Approved Landscape Plan

Viewpoint - Stage F1
Huntly, Bendigo

Contents, Context Plan and Plant Schedule

Street Landscape Plan 1			
Drawn	Approved	Date	North
AD	RH	27.01.2022	
Scale (A1)	Scale (A3)	Sheet	
1:250	1:500	2 of 3	
This drawing and design is protected by copyright © PLOT Landscape Architects Pty Ltd. www.plotla.com.au			
Drawing Number	Revision		
PLA452-L02	TP2

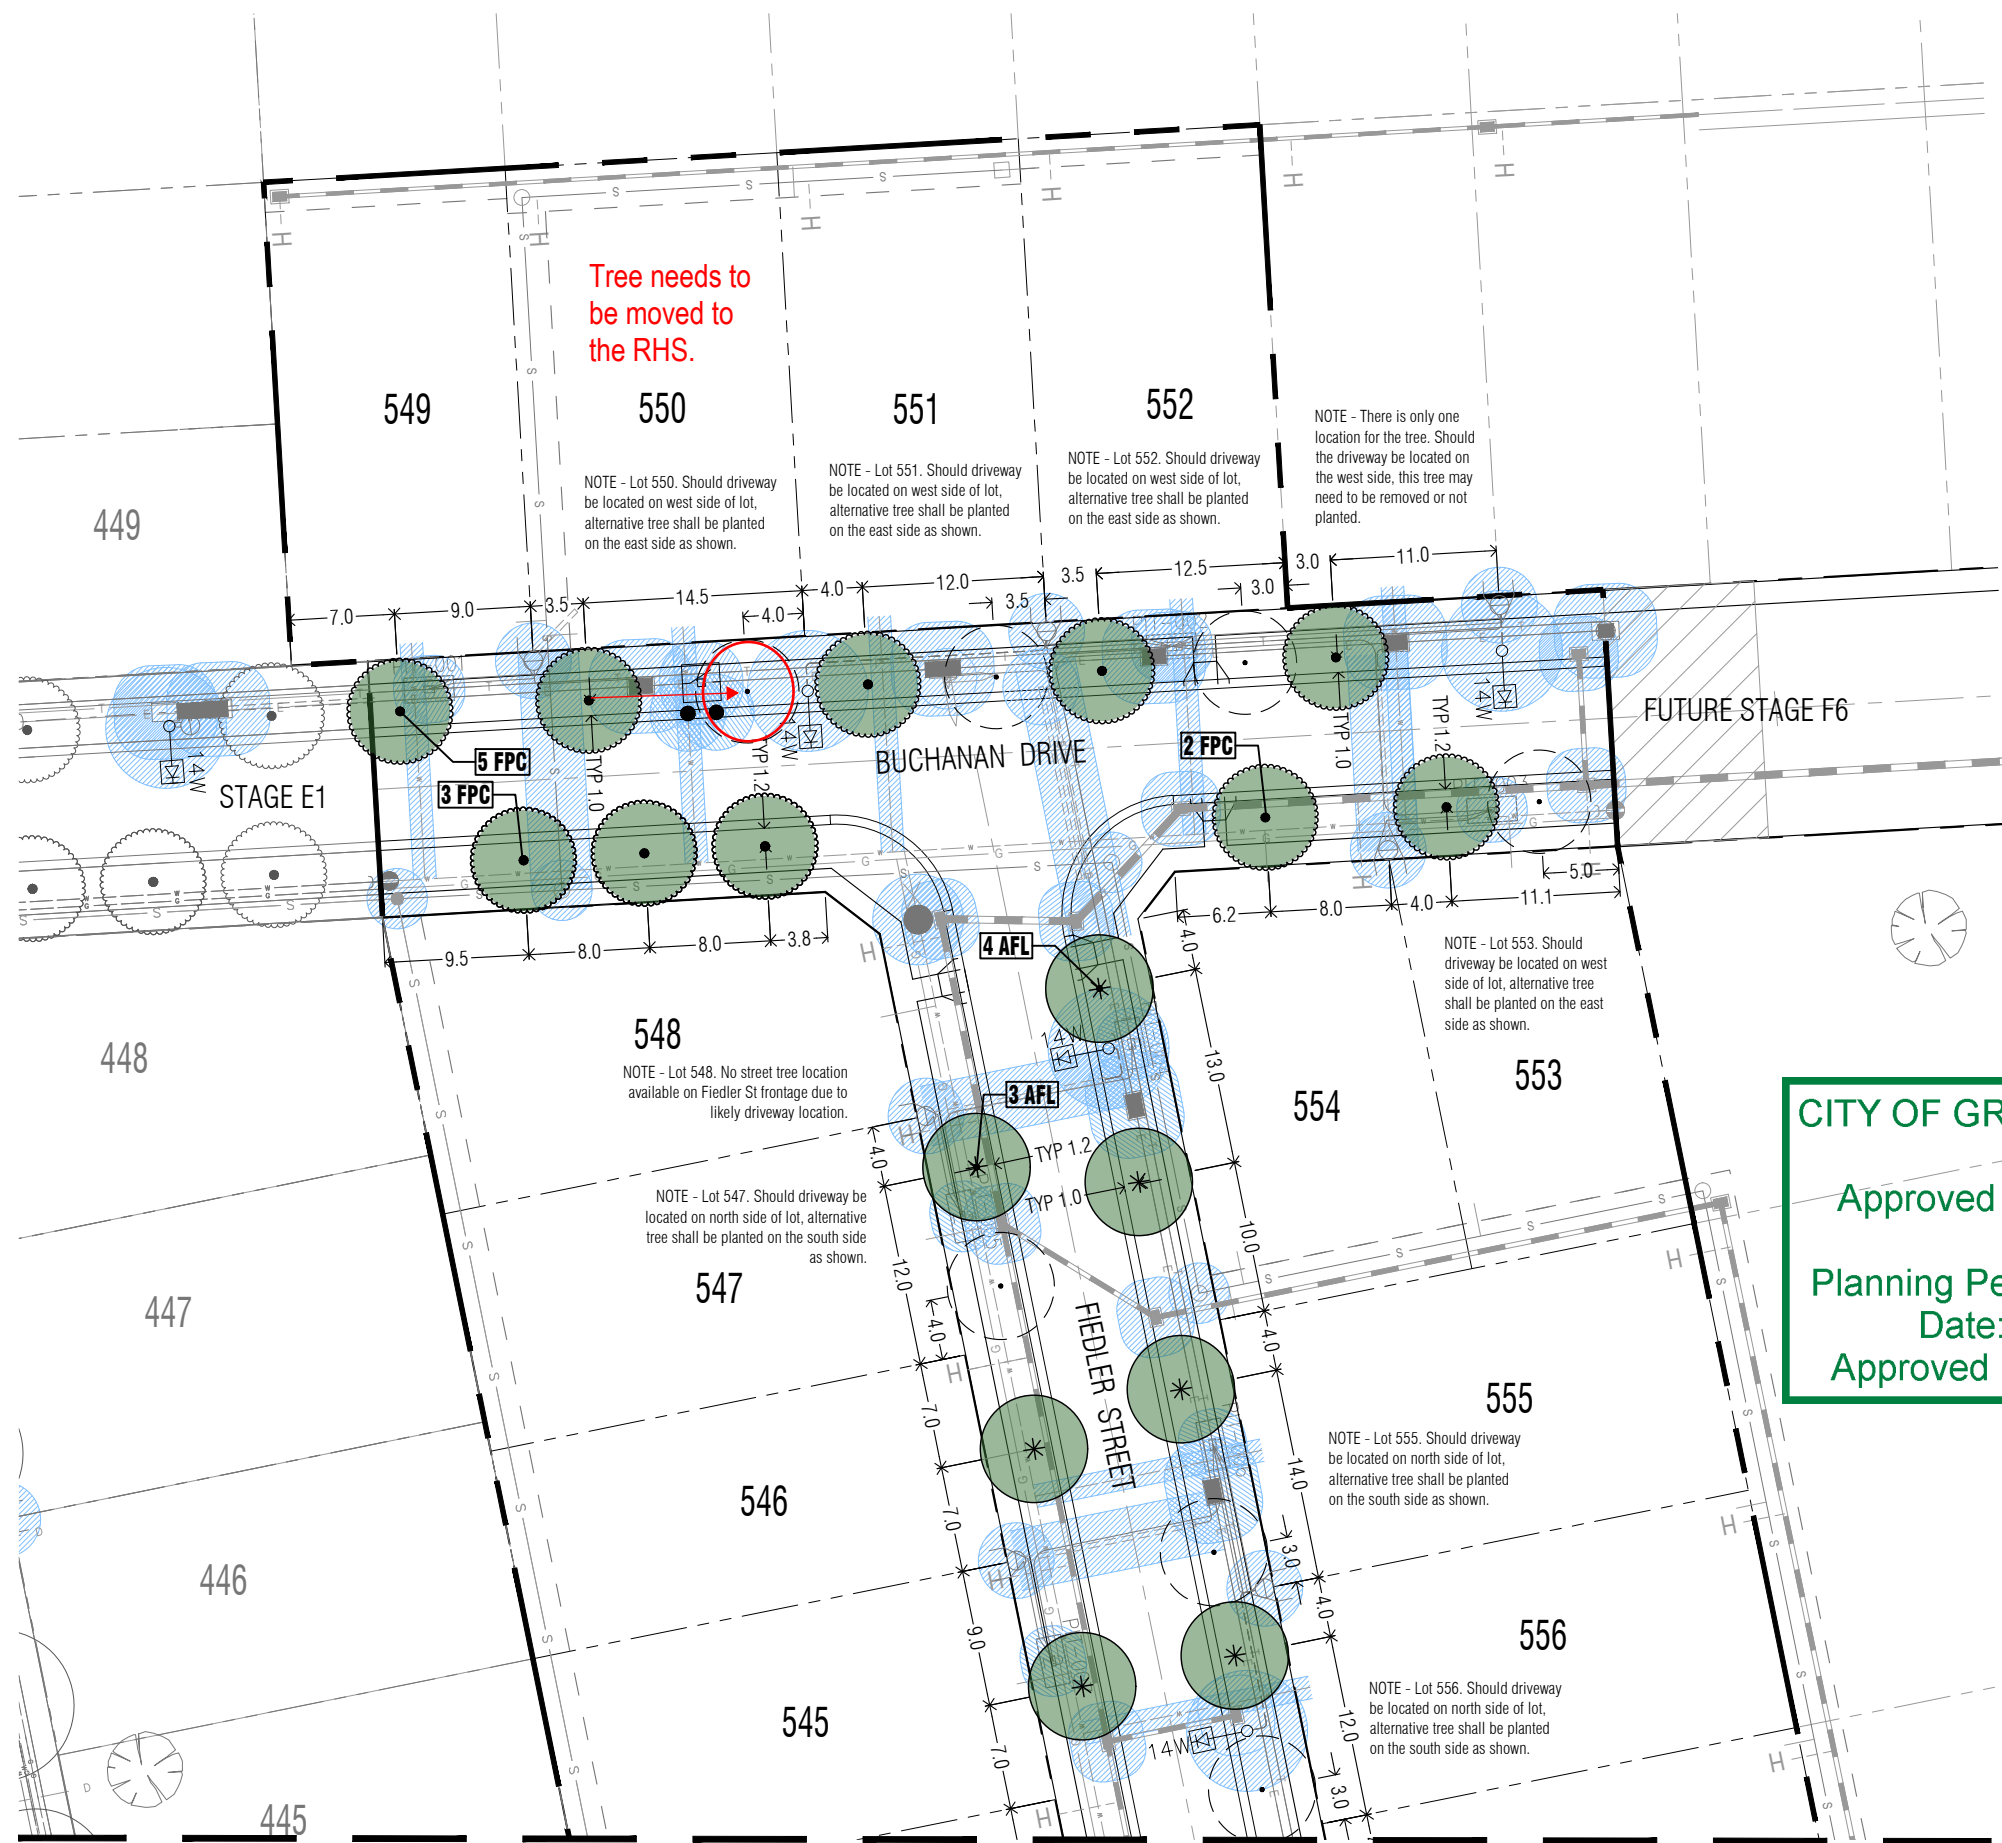
Tree needs to be moved to the RHS.
